TSG-RAN Meeting #19 *RP-030104*
Birmingham, UK, 11 - 14 March 2003

Title: **CRs (Release '99 and Rel-4/Rel-5 category A) to TS 25.331 (2)**

Source: **TSG-RAN WG2**

CHANGE REQUEST

Figure 8.4.2-1: Measurement report, normal case

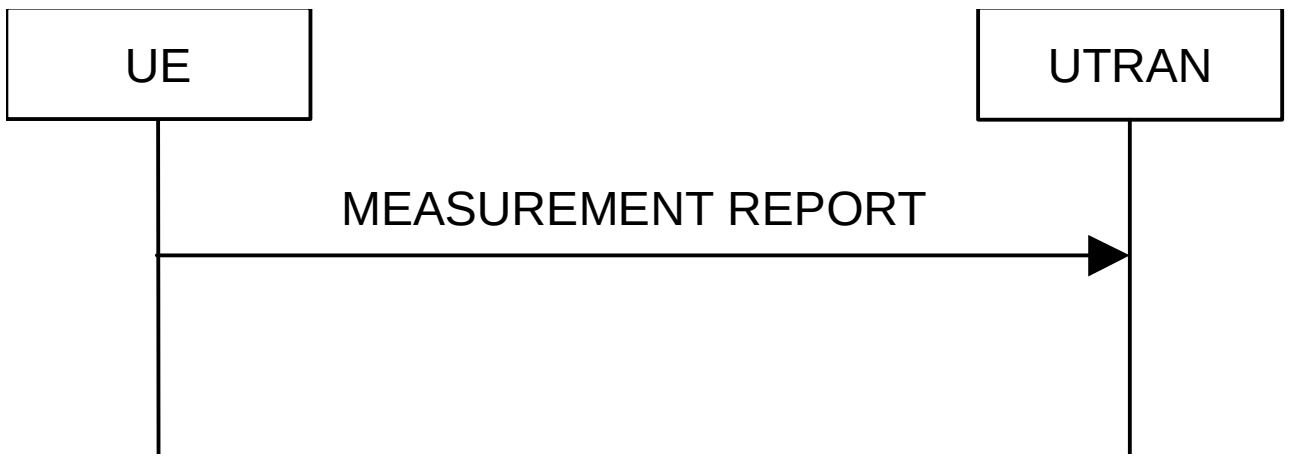
Reason for change:	⌘	It is stated in clause 8.4.2.2 of 25.331 that the UE shall sort the additional measurements reported in MEASUREMENT REPORT message according to their "Measurement Identity" IE. It is not clearly specified how the UE should behave when not all of the additional measurements are available, but because the order of "Measurement Identity" is kept, all Additional Measurements must be sent. From the tabular notation, the IEs for reporting the measurement types described by cl 10.3.7.44-25.331 are optional (e.g. "Intra-Frequency measured results" included in "Intra-Frequency measured results list", cl 10.3.7.35 – 25.331). However, the ASN.1 defines all measurements types, in their respective results list, as mandatory. Therefore, it is not clear what the UE should send in the Additional Measurements if at the time of sending the report some results are missing.
Summary of change:	⌘	The limit of configured additional measurements is reduced to 1 per type (ie. The maximum of 4 is still kept, but they have to be of different types). It is stated that if the UE receives a configuration with more than one additional measurement of the same type, the UE behaviour is unspecified. **Impact Analysis** If only the UE implements the CR and more than one additional measurement of the same type is configured, the UE behaviour is unspecified. If only the UTRAN implements the CR the UE may send garbage on the mandatory fields or omit the additional measurements completely.

Consequences if not approved:	⌘	The UE will either send garbage on the mandatory fields or it will omit the additional measurements completely until results for all types are available. The former could mislead the UTRAN into considering measurement results that
